WADE ONE - HELIOS JSP24-05

JSP24-05 Wade One - Helios

Public Hearing at the request of Integrity Building Group for a Special Land Use Permit and Preliminary Site Plan approval. The subject property, 45241 Grand River Avenue, is an approximately 29,000 square foot building on a 7.61 acre parcel within the I-1 Light Industrial Zoning District. The site is located south of Grand River Avenue and east of Taft Road. The applicant is proposing to operate a single business out of an existing industrial building. Helios is a company that manufactures stone-cutting equipment and assembly/shipping of purchased equipment.

MOTION SHEET

Sheet Number:
C2.11
 © 2024 studioONE, LLC

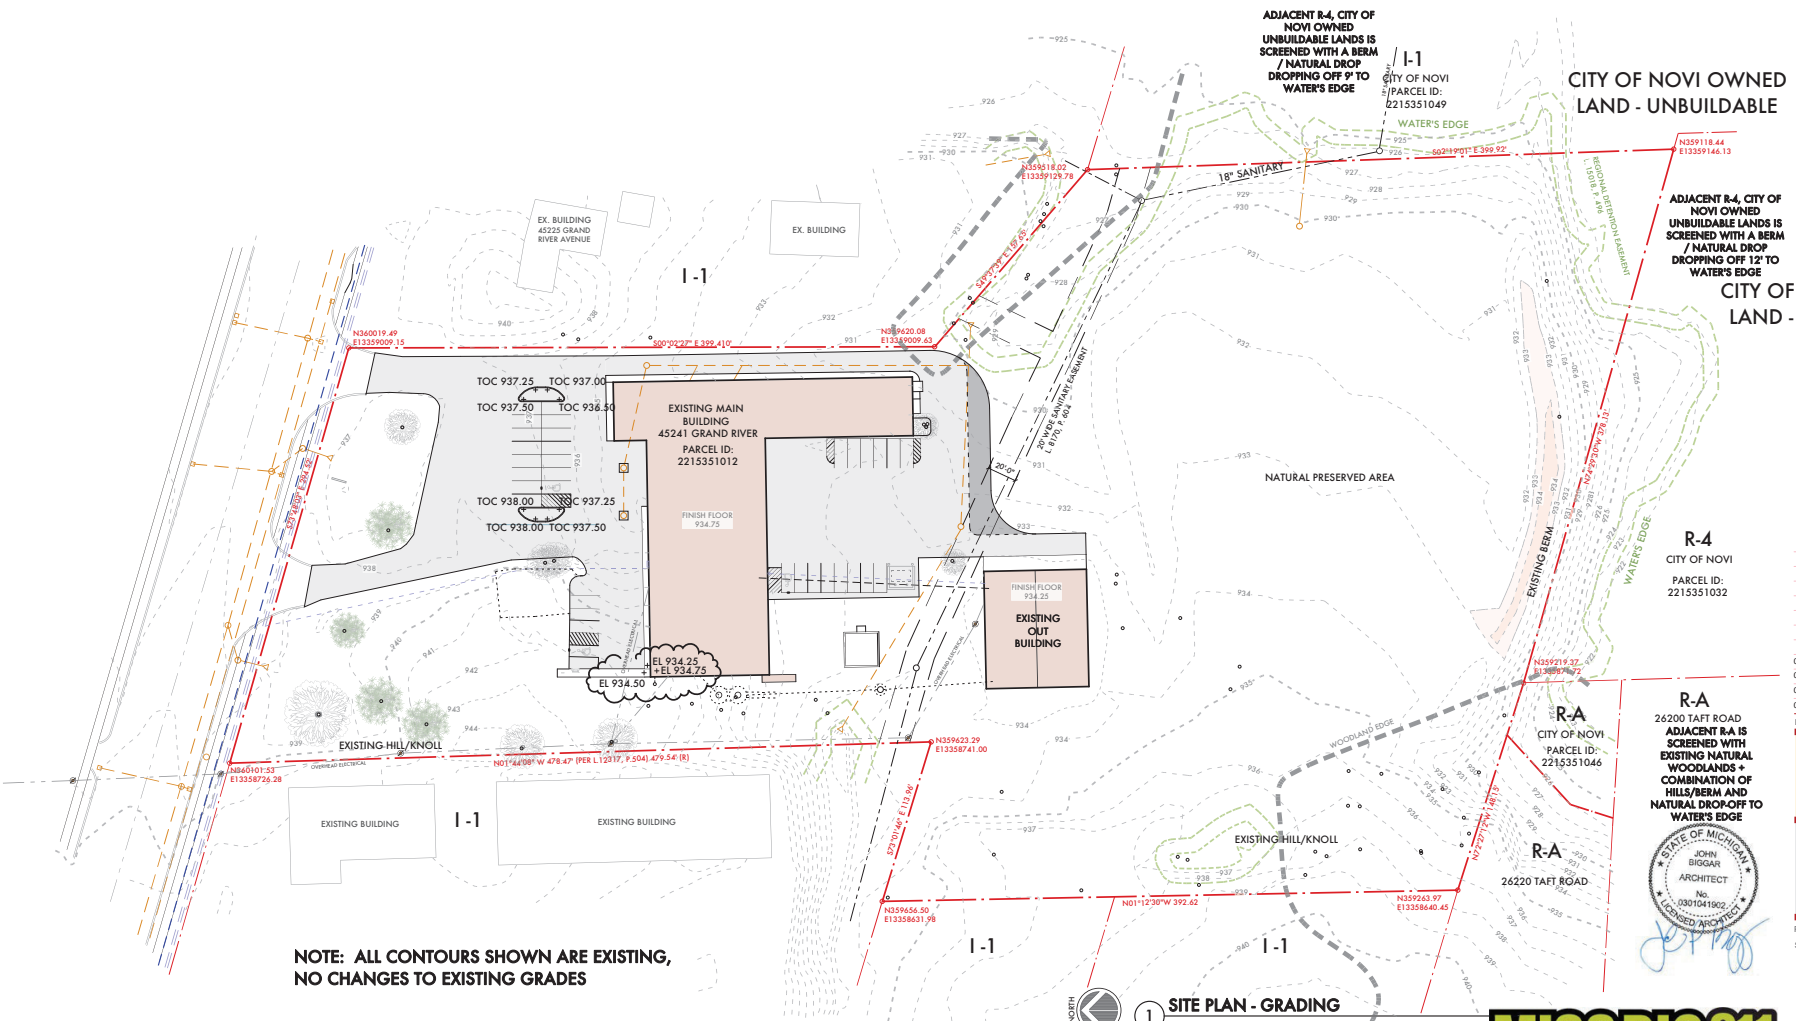
- a. Only add proposed materials to the C2.11 table; include sidewalk, concrete pad, and end islands
 - b. Concrete pad plan view detail still shows 6" slab instead of 8"; section view is correct with the 8" on 8" though

- c. Add note on C2.11 that end islands are proposed
Show top of pavement spot elevations alongside the toc elevations to ensure 6" curb around the end islands

- e. Only include proposed signs in the C2.11 signing table
 - f. No NPDES permit needed
- b. Landscape Review: Landscape recommended approval of the combined Preliminary and Final Site Plan, contingent on the applicant making the necessary correction as stated in the Landscape review letter to remove the one unsupported waiver. **Please be sure to review the Landscape review letter and address the unsupported waiver in your response letter and on the Electronic Stamping Set.**

- a. Proposed Materials – Added sidewalk, concrete pad and end islands
- b. Concrete Pad – Detail 2/A2.60 updated to 8” concrete pad
- c. End Islands – Note 16 adding indicating the curbs and end islands are new. The spot elevations are shown on the Grading Plan C2.12.
- d. ADA Sidewalk Elevations – Note “The proposed sidewalk shall meet existing elevations/grades and ADA standards where they meet” is added to drawing C2.11 Layout Plan and C2.12 Grading Plan.
- e. Signing Table – Only signs being used are in the table. Graphic symbols of the (3) signs added to drawing C2.11

- Signing Table – Only signs being used are in the table. Graphic symbols of the (3) signs added to drawing C2.11. Only (2) R7-8A Van Accessible signs are being provided.

Sheet Number:
C2.61

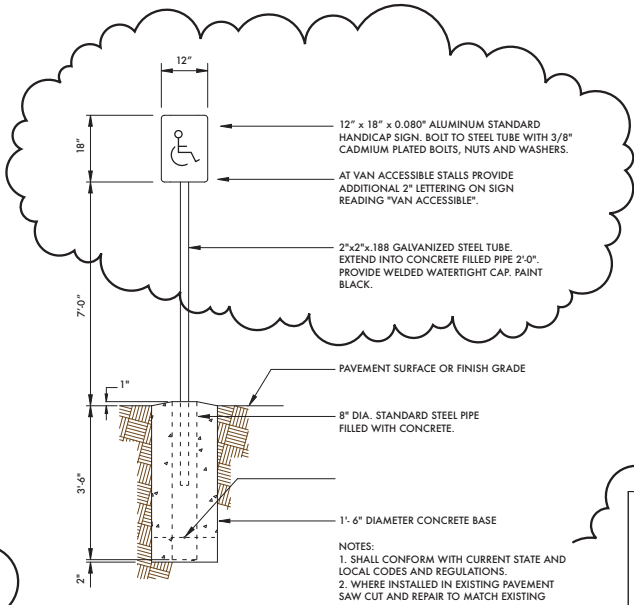
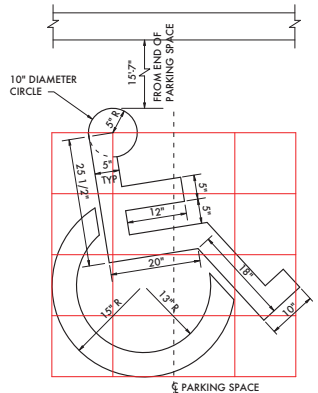
SIGNING AND STRIPING				
No.	Item	Proposed	Compliance	Remarks
32	Signing: Sizes MMUTCD	Provided	Partially Met	Detail 4 on sheet C2.61 should show a separate R7-8p sign to be added for van accessible space and not just adding 2" lettering to the R7-8 sign.
33	Signing table: quantities and sizes	3 R7-8p and 2 R7-8 signs listed	Partially Met	There should be both a R7-8 and a R7-8p sign only at the van accessible spaces, quantity should be 3 R7-8 signs and 2 R7-8p sign. Also mislabeled on the site plan.
34	Signs 12" x 18" or smaller in size shall be mounted on a galvanized 2 lb. U-channel post MMUTCD	Indicated	Met	
35	Signs greater than 12" x 18" shall be mounted on a galvanized 3 lb. or greater U-channel post MMUTCD	Indicated	Met	
36	Sign bottom height of 7' from final grade MMUTCD	Indicated	Met	
37	Signing shall be placed 2' from the face of the curb or edge of the nearest sidewalk to the near edge of the sign MMUTCD	Indicated	Met

- All proposed barrier free signs are shown on C2.11 Layout Plan and on the details on drawing C2.61.

Figure 1. City of Novi Regulated Woodlands Map
Approximate Site boundary is shown in Red.
Regulated Woodland areas are shown in Green

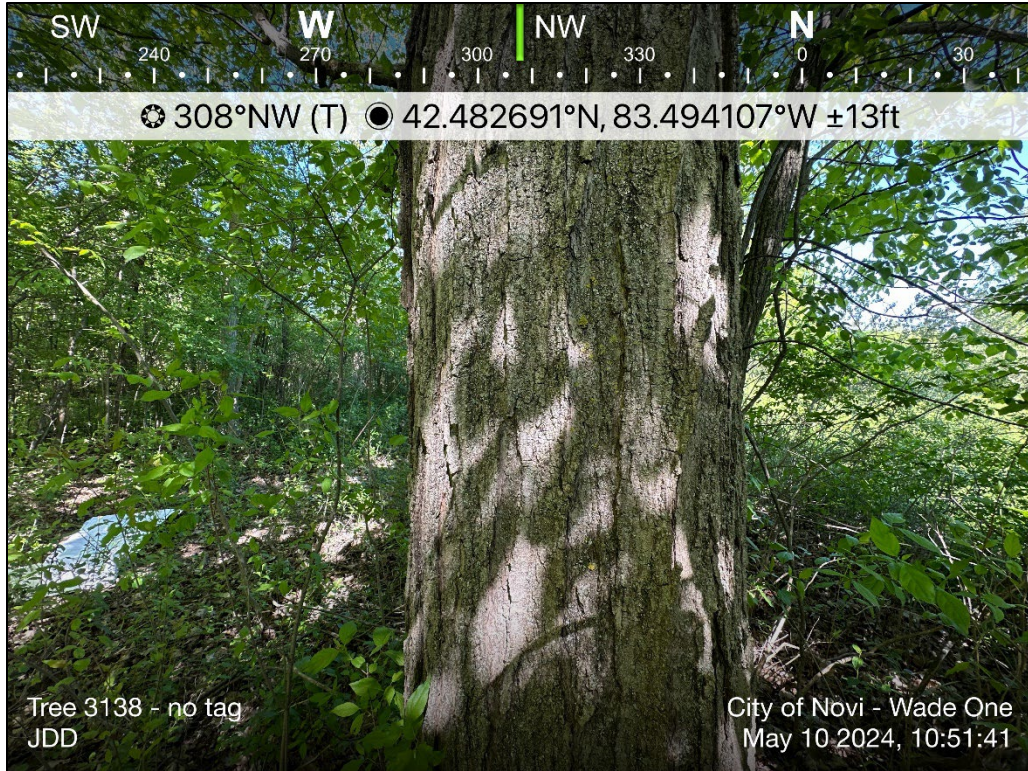
1. City-regulated woodlands, as identified on the City of Novi Woodlands interactive map website, are present onsite. Note that both the woodlands and property limits depicted on the City map are considered approximations (**Figure 1**). Select photos from the site visits are included in **Attachment A**.
2. When a proposed site plan is located within a regulated woodland, any tree proposed for removal with a diameter at breast height (DBH) greater than or equal to eight inches will require tree replacement

Approximate location of Tree 3138 with no tree tag identified on-site.

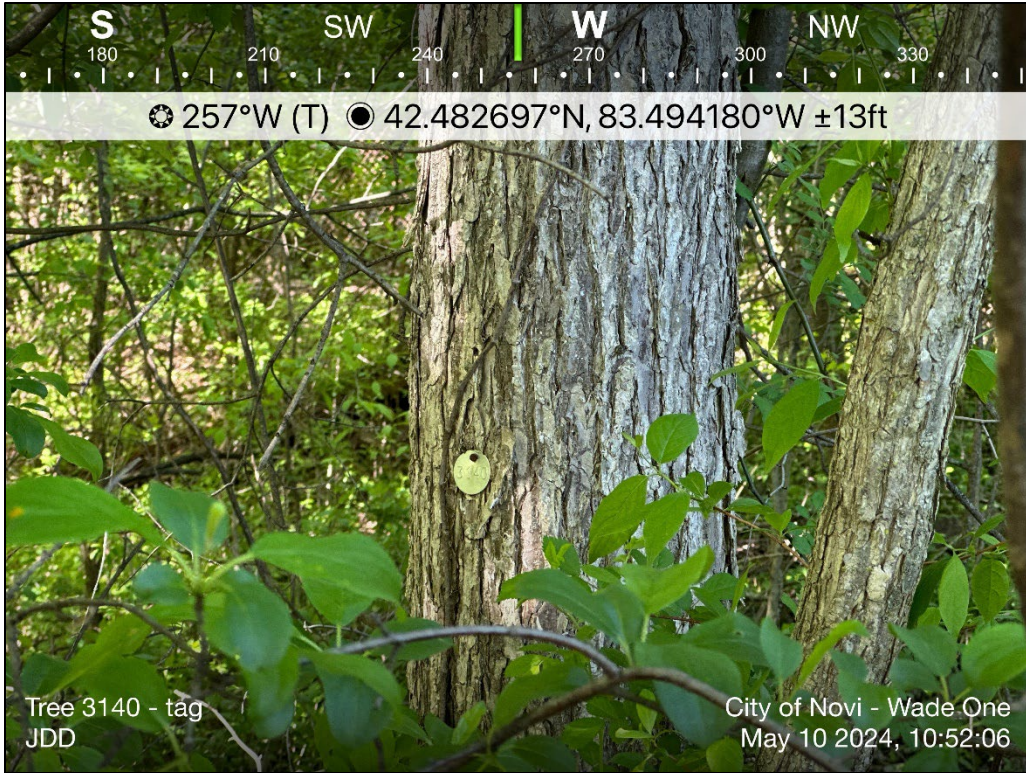
Approximate location of Tree 3138 with no tree tag identified on-site. Tree is identified as having a DBH of 17 in the site plans but was found to be closer to 21.7 inches DBH.

Tree 3140 was tagged accurately.

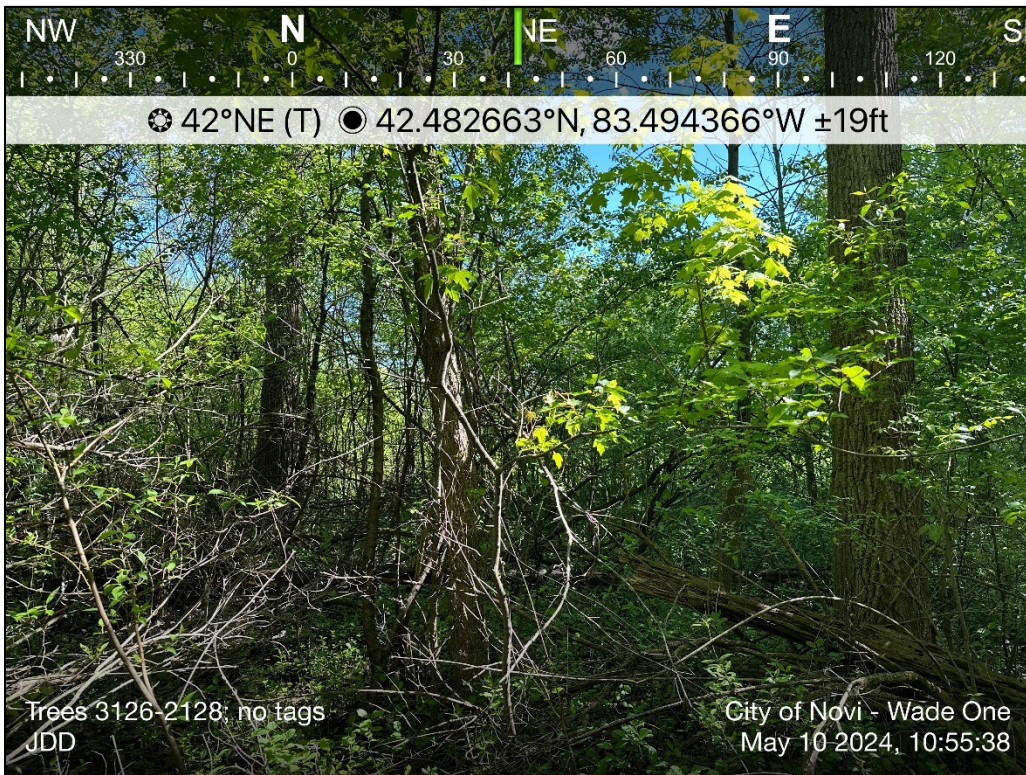
Trees 3126-3128 all contained no tree tags.

Tree 3137 contained no tree tag. Site plans identified tree as being 11 inches DBH but on-site inspection revealed tree is closer to 13 inches DBH.
